Subject: Gelson's Working Group to Identify Analyses for March 22 Meeting

## Required Environmental Impact Analyses for Gelson's

**EXHIBIT 2**

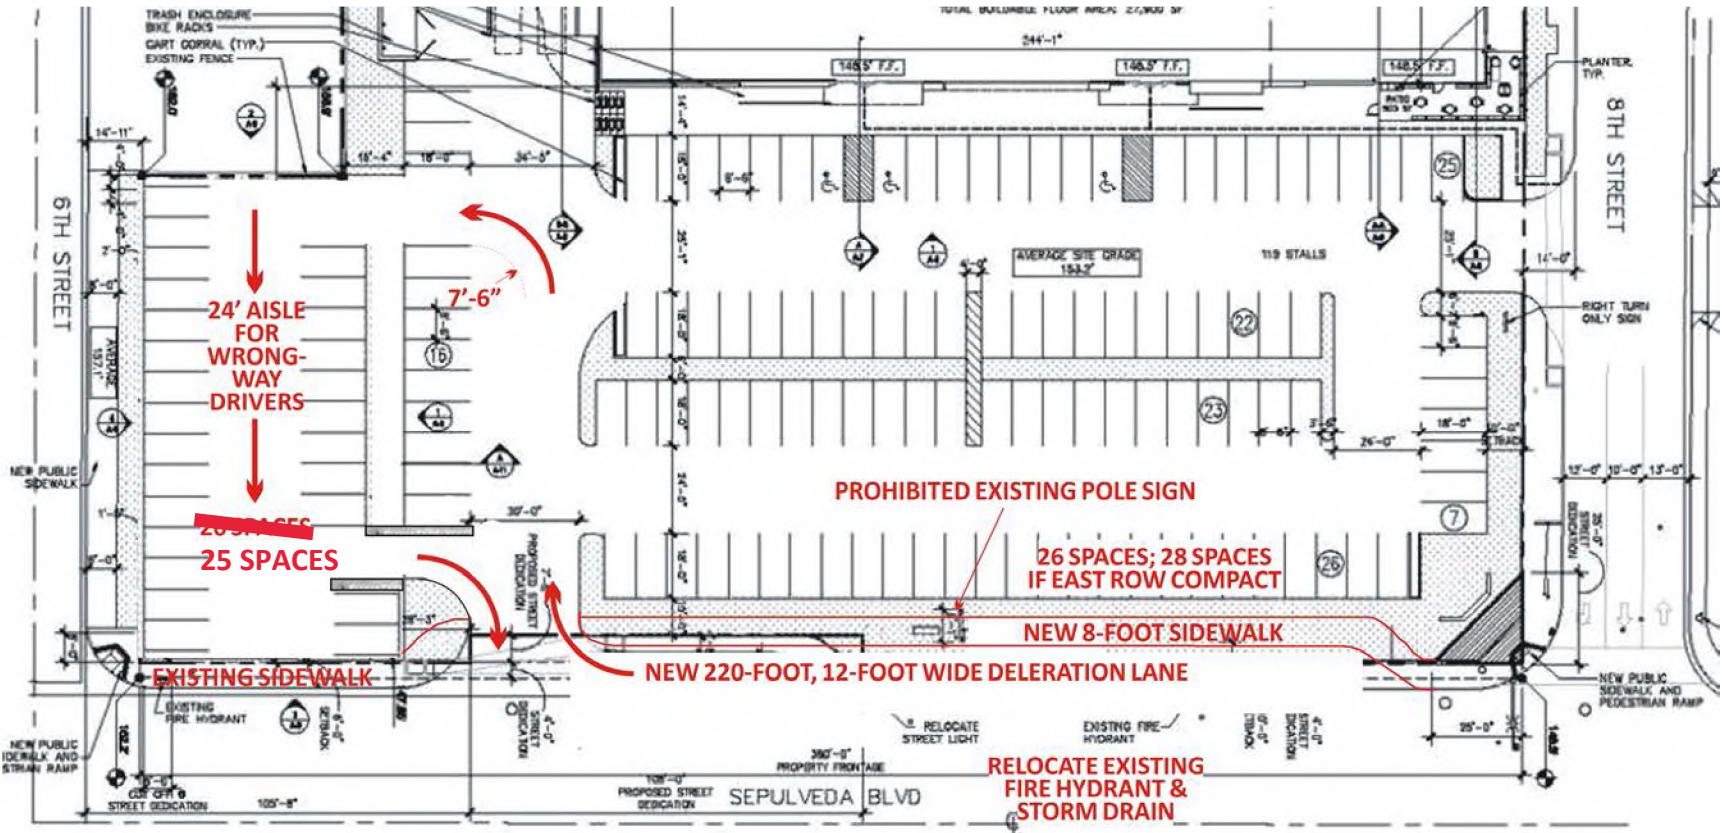
**CORRECTION: 140/142 SPACES, NOT 141/143.**

**140/142 + 16=156/158 vs 152 REQUIRED**

**PARAGON HAS 140-25+4 = 119 SPACES + 16 = 134**

**REVISED PARKING PLAN REMOVES BANK AND PROHIBITED POLE SIGN**

- Prohibited pole sign removed to make way for conforming deceleration lane
- 220-foot, 12-foot wide deceleration lane added along Sepulveda
- South Parking replaced bank, to comply with parking requirements
